Sections 2

DRAWING TITLE:
Section 3

P/A	12/04/2024	Issue For Development Application																																	
B	8/05/2024	Issue For RFI																																	
C	11/07/2024	Issue For RFI																																	
D	15/07/2024	Issue For RFI																																	
E	30/07/2024	Issue For RFI																																	
F	23/08/2024	Issue For RFI																																	
G	10/04/2025	Issue for S4.55																																	
CLIENT: WINIM Developments Pty Ltd																																			
101 pbd architects P - 02 9698 8140 E - info@pbdarchitects.com.au W - pbdarchitects.com.au Level 2, 52 Allison Street, Surry Hills NSW 2010 ABN 36 147 035 550 Nominated Architect: Paul Buljevic NSW 7768																																			
PROJECT: Residential Flat Building 1 Gatacre Ave & 1-5 Allison Ave, Lane Cove

DRAWING TITLE: Photomontage - Allison Avenue																																			
<table><tr><td>DRAWING BY:</td><td>CHECKED BY:</td><td>DATE:</td></tr><tr><td>GR</td><td>Checked by KA</td><td>10/04/2025</td></tr><tr><td>SCALE:</td><td>DRAWING NO:</td><td>ISSUE:</td></tr><tr><td>NTS</td><td>DA410</td><td>G</td></tr><tr><td>PROJECT N

DRAWING TITLE:
Height plane overlap-Building A
- Roof

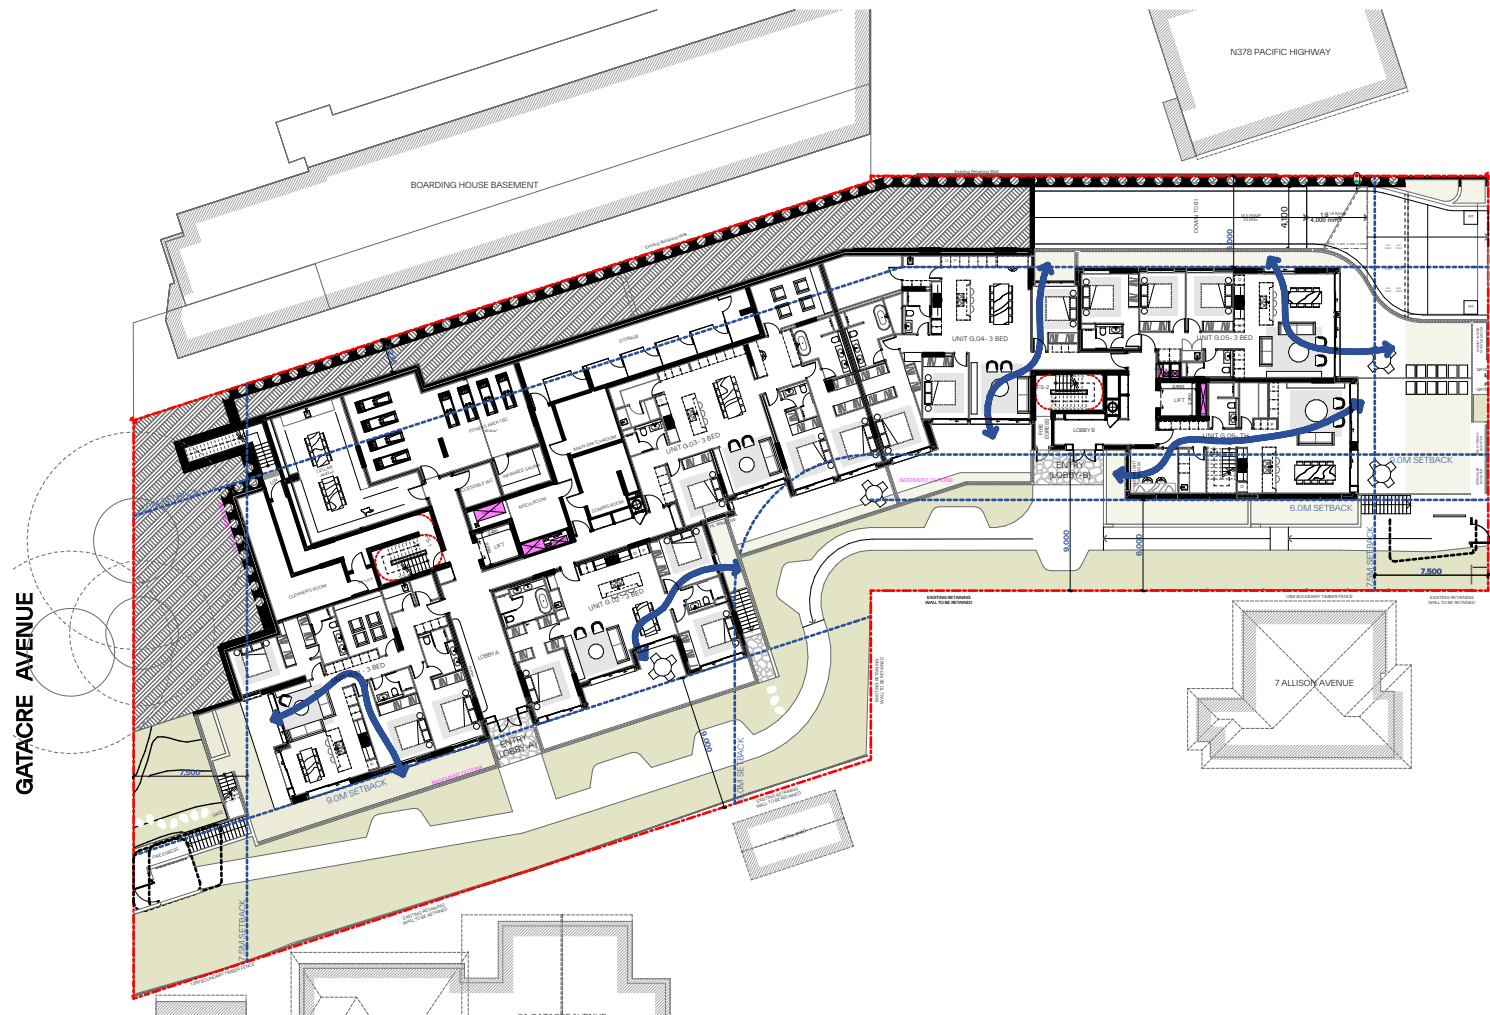
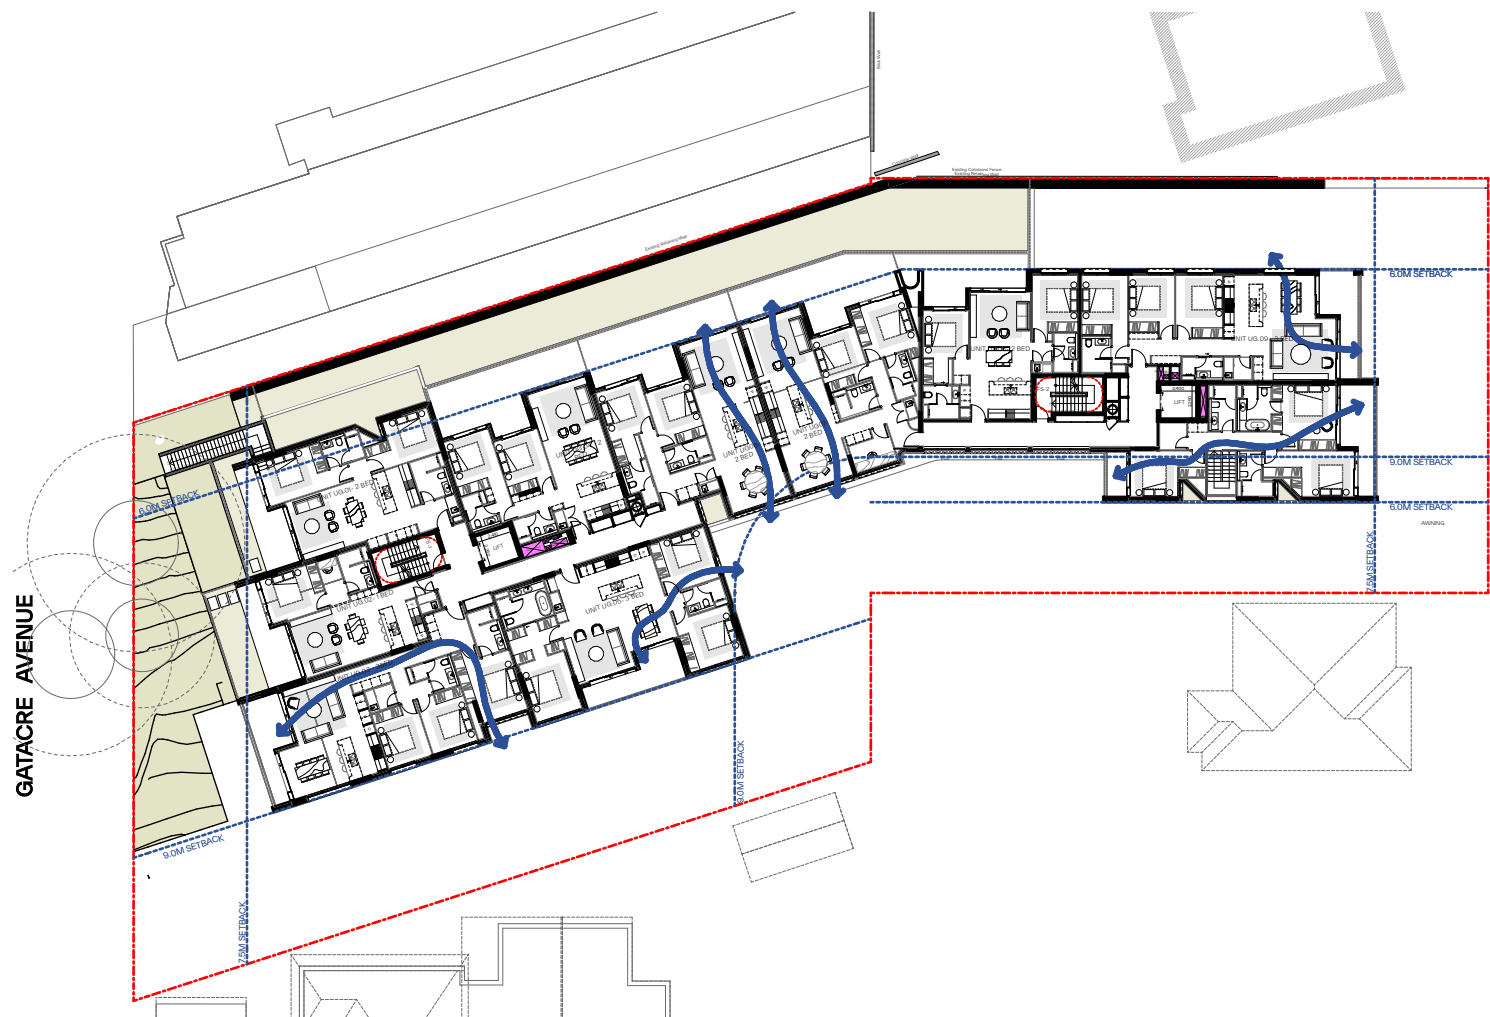
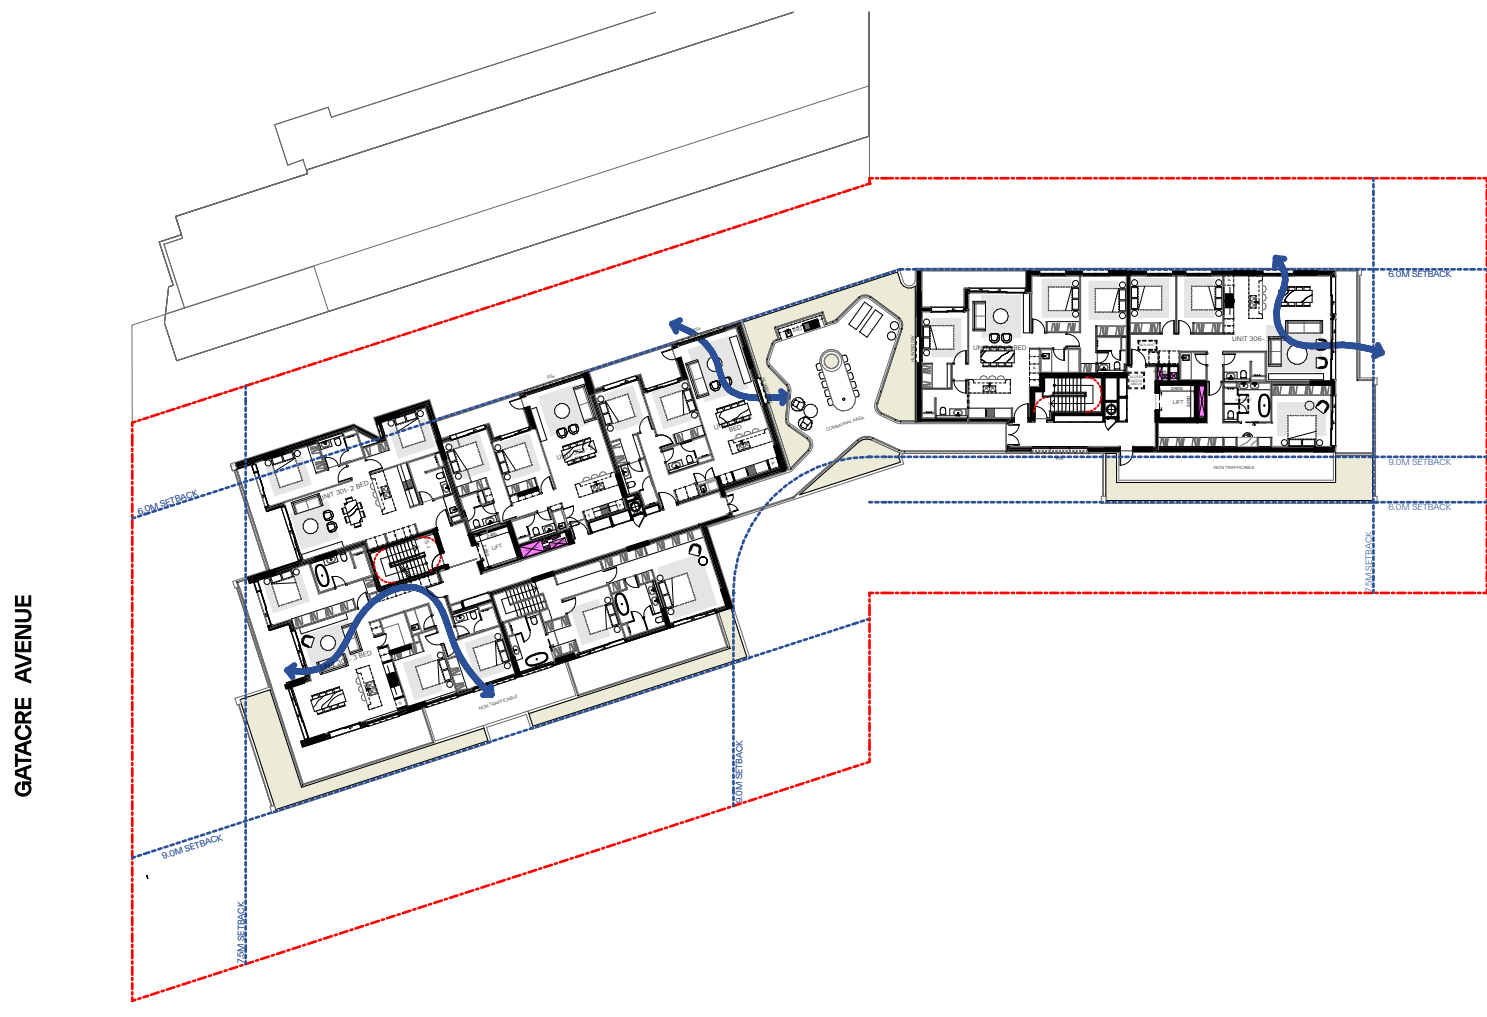
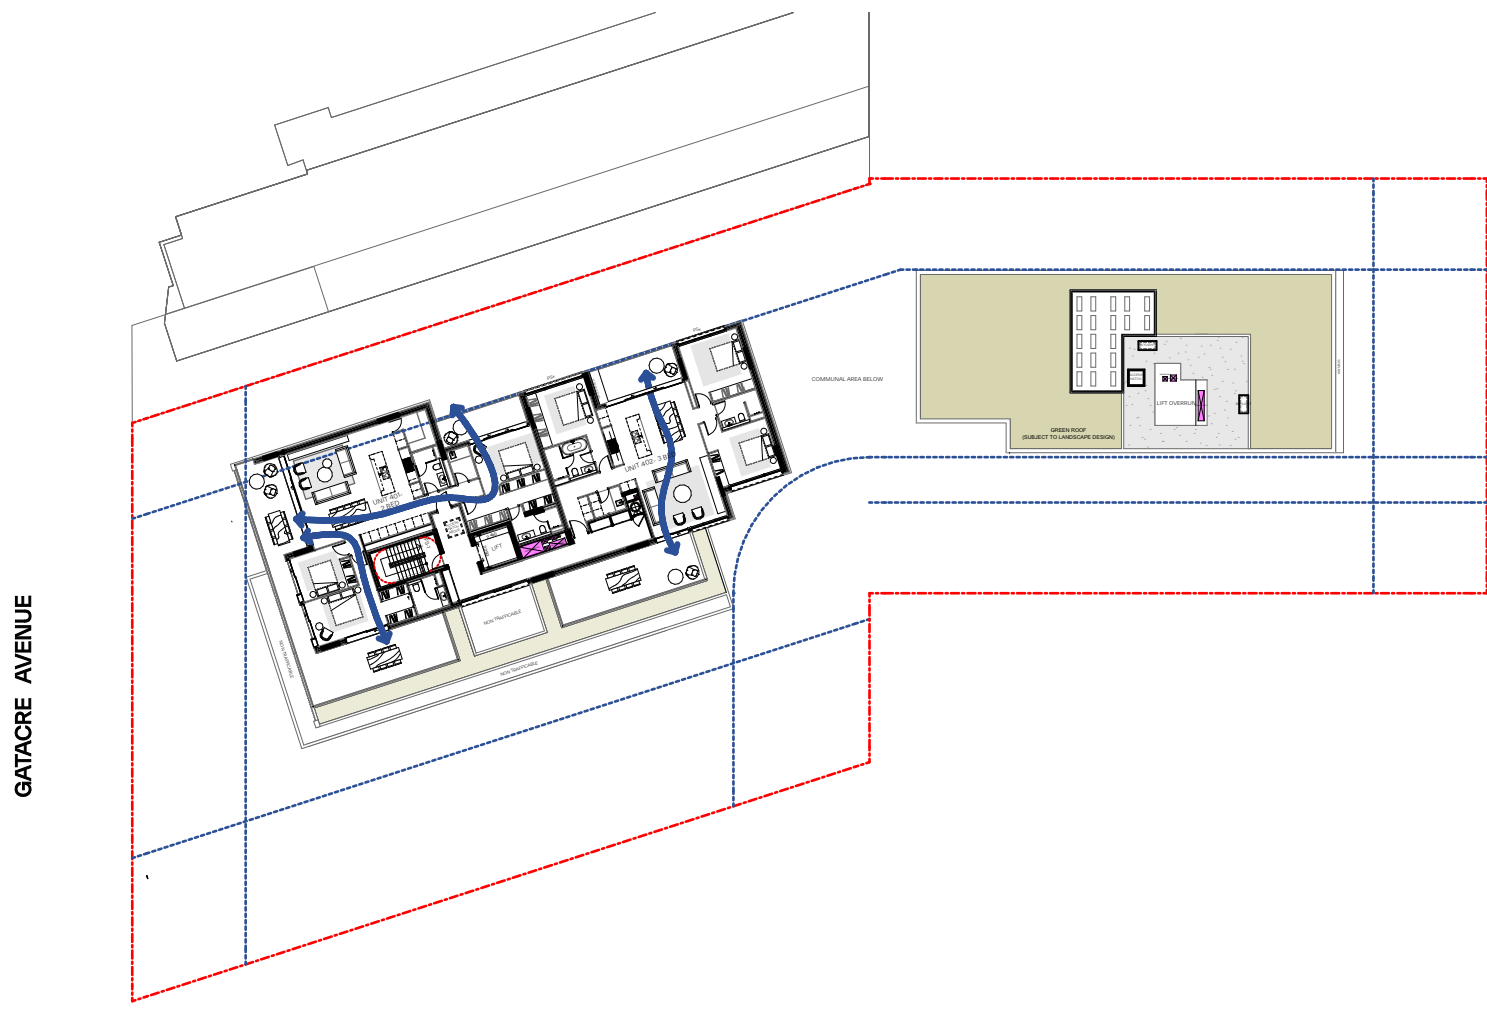
- PLANT AREA HEIGHT REDUCTION - THE HEIGHT OF THE ROOFTOP PLANT AREA HAS BEEN REDUCED FROM 18M TO 12M.
 - EXTENDED PLANTER BOX - THE PLANTER BOX HAS BEEN EXTENDED BY 500MM TO FURTHER ENHANCE PRIVACY TO 2A GATACRE AVENUE.

- ADDITIONAL WATER FILTER AND STORAGE TANK - A NEW WATER FILTER AND STORAGE TANK HAVE BEEN ADDED TO GROUND FLOOR.
 - COMMON AREA AND SERVICE AREA LAYOUT AMENDMENT - THE LAYOUT OF COMMON AND SERVICE AREAS HAS BEEN REVISED FOR BETTER FUNCTIONALITY AND CIRCULATION.
